Barry to Dinas Powys Active Travel route options

Consultation report

Route option 1

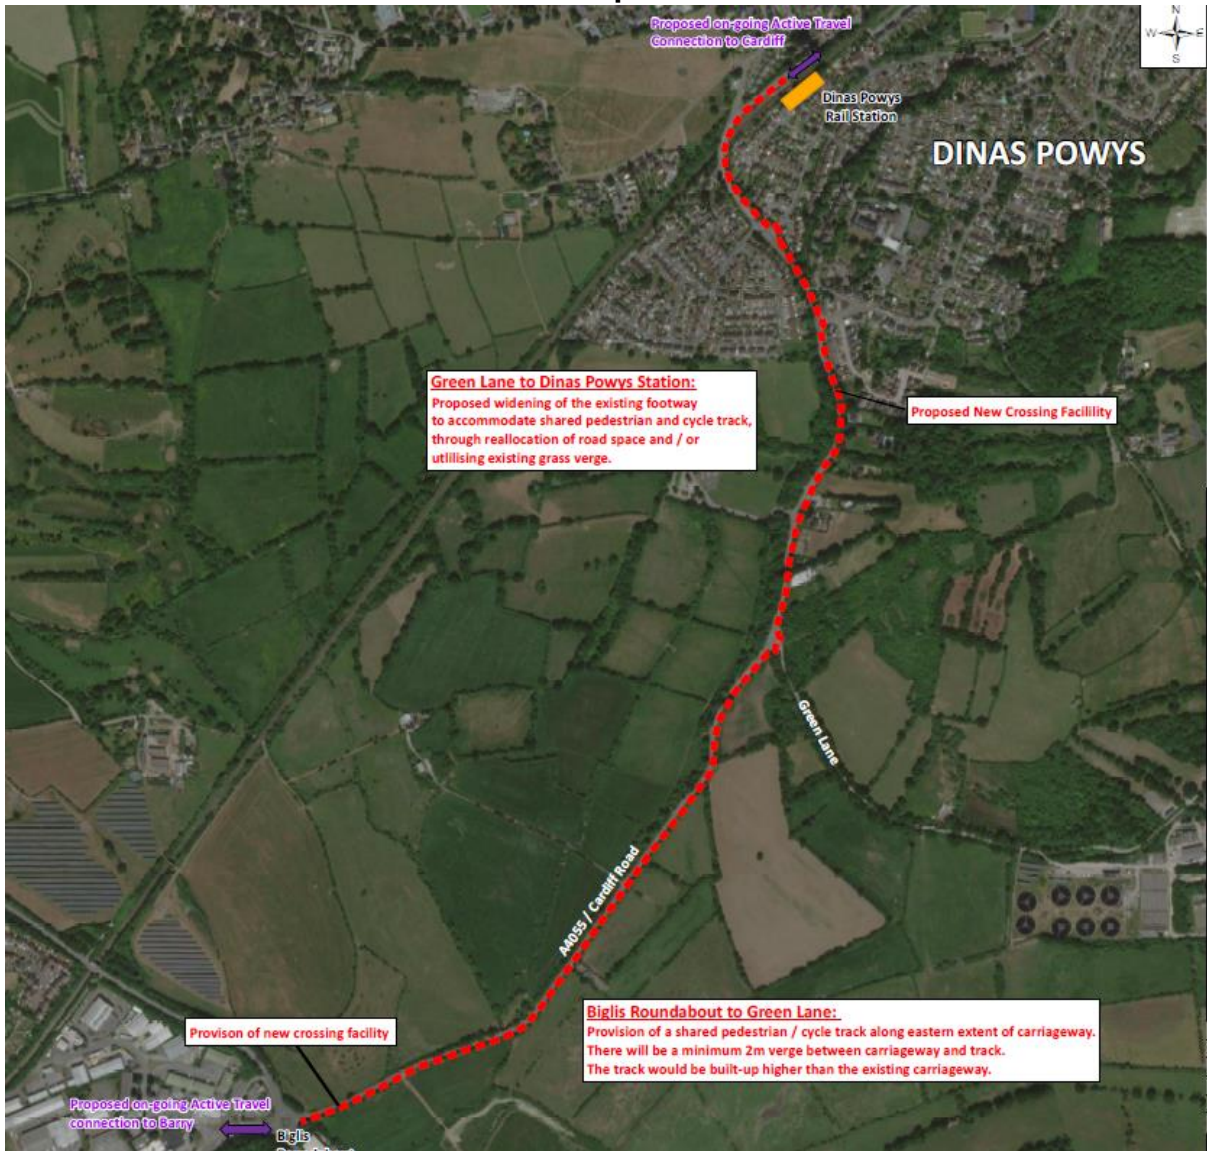
- 29 'would walk/cycle/wheel here'.
- 23 think it 'does not feel safe'
- 18 think it is the 'shortest distance'

- 4 people added 'something else'. These comments were:
 1. The road is too narrow.
 2. Can't see how this is feasible along such a busy road. Pollution fumes etc. I don't understand which bit is 'raised' – how will this affect residents?
 3. The speed on Cardiff road needs addressing. Cars fly through.
 4. Crossing the cross common junction Dinas Powys to Barry.

- Concerns over removal of hedgerow and effects to wildlife.
- The route is alongside traffic.
- It is a direct route.
